Property Location:	417 Sandgate Road, Albion QLD 4010
Property Description:	Lot 1 on RP127006
Development:	Minor Change
Applicant:	Good Karma (Salisbury) Pty Ltd
Council Reference:	A006993195

We refer to Council's Further Advice dated 22 May 2026 and, on behalf of our client, forward the following as a **full** response to **all** requested items.

Figure 1 - Section

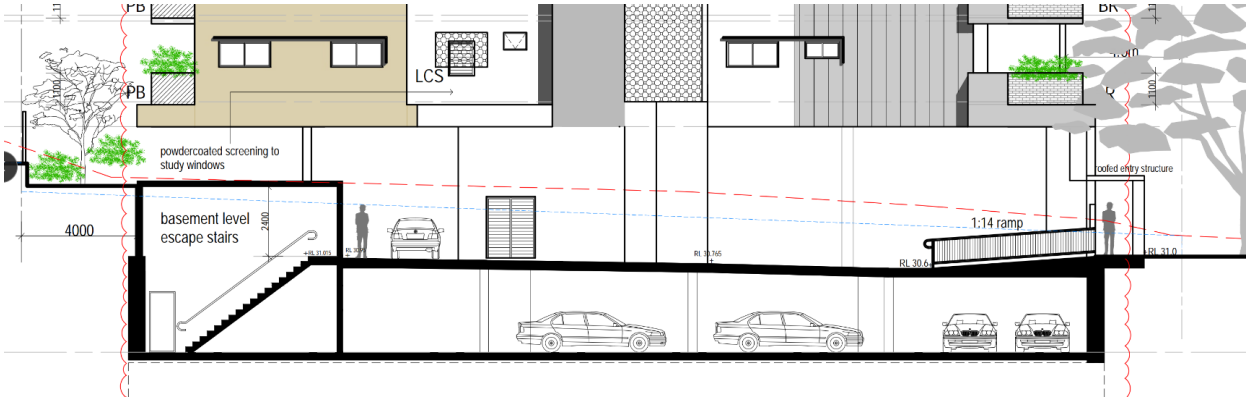
1. The proposed change results in a significant reduction in the provision of landscaping to the ground floor. In particular, a large landscape area located along the eastern side boundary which contained tree plantings is proposed to be removed, however, the submitted drawings do not demonstrate the proposed design changes reduce the appearance of building bulk and softens built form and hardstand areas from the adjoining property.

a. Provide amended plans in accordance with Multiple dwelling code AO28.2/PO28 and reintroduce landscape areas along the eastern side boundary capable of supporting screening trees/shrubs.

The area of planting on the existing eastern side boundary is in significant cut, refer Figure 1. The landscaping is not visible from the property adjoining to the east. This landscaping is not appreciable form the street, located behind the fire pump room, letter boxes and a pedestrian ramp. Where the adjoining site to the east does view the building, the building includes containerised planters which have a side interface, plus an articulated building wall alignment.

Figure 4 – Proposed Albion Station Upgrade

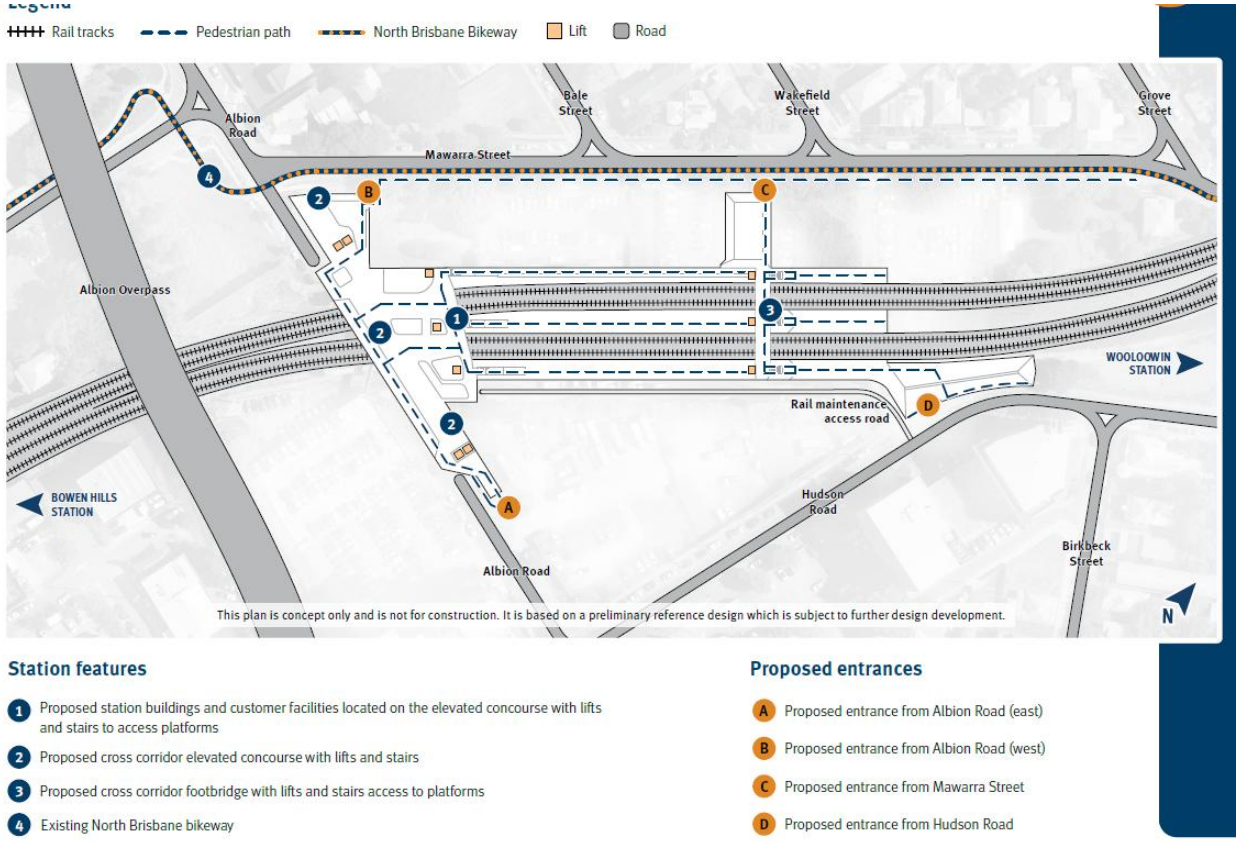
3. It is acknowledged the proposed changes include a reduction to the number of car parking spaces for both residents and visitors on the basis of the location of the site relative to Albion Railway Station. While a performance outcome for car parking is able to be considered, the basis for the reduction is considered to be reliant on an unsafe path of travel to the train station and further, updated information is required to demonstrate compliance with PO13 and PO14 of the Transport, access, parking and servicing code.

a. Submit an updated Traffic Statement demonstrating the proposed on-site car parking for residents and visitors accommodates peak parking demand for the development without overflow onto adjacent streets; and that the design peak parking demand is met.

The proposed development provides 21 resident and 3 visitor car parking spaces. A total of 8 one-bedroom, 4 x two bedroom and 7 x three bedroom units are proposed. As identified in the amended traffic report (refer **Attachment D**), the site is in a highly urbanised area with varied access to both high frequency rail and bus services. In addition, with the proposed upgrade to the Albion Station, new access locations will be provided on Hudson Road and Albion Road, which provide an improvement in the accessibility to the proposed station (refer Figure 4). The site is also located in proximity to significant commercial and every day amenities, including an approved full line Woolworths supermarket proposed at the former Albion Mill Site (Add in a figure to demonstrate the proximity to those amenities), refer Figure 5 below. The traffic report identifies that given the proximity of the site to these services, and unit mix, that overflow car parking is not expected.
